January 18, 2019
Subject: Recall R89910
TO: All U.S. and Canadian Volvo Retailers

**R89910: Tailgate Lift Arms (Drive Units)
Model Year 2018 – 2019 XC60**

Title	Inspection and replacement of "drive units", tailgate lift arms	Page:	1 (5)
Action

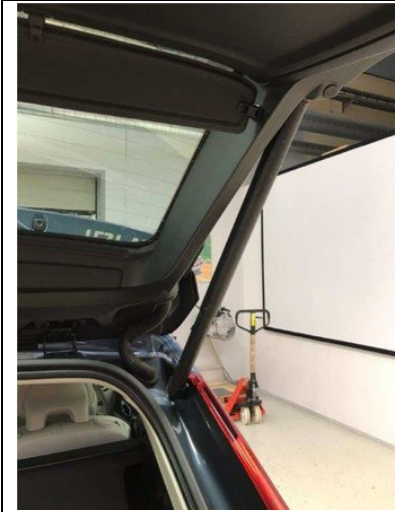
Please note that we have 3 different conditions, see attached pictures "Instruction OK Not OK".

-Condition 1, replace the lifting arms according to VIDA VCC-370949-5.

-Condition 2, Adjust and fasten the outer tube according to attached document "Instruction". Then replace the lifting arms according to VIDA, VCC-370949-5

-Condition 3, with a bent lifting arm(s) follow the attached "VIDEO". Cover the tailgate, open and close the tailgate until the bent lifting arm(s) is broken. Replace the lifting arms according to VIDA, VCC-370949-5.

Condition 1

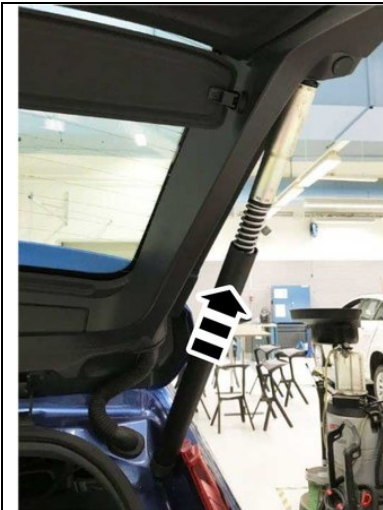
If motor, power operated tailgate looks according to image, both dampers are to be replaced according to Vida:
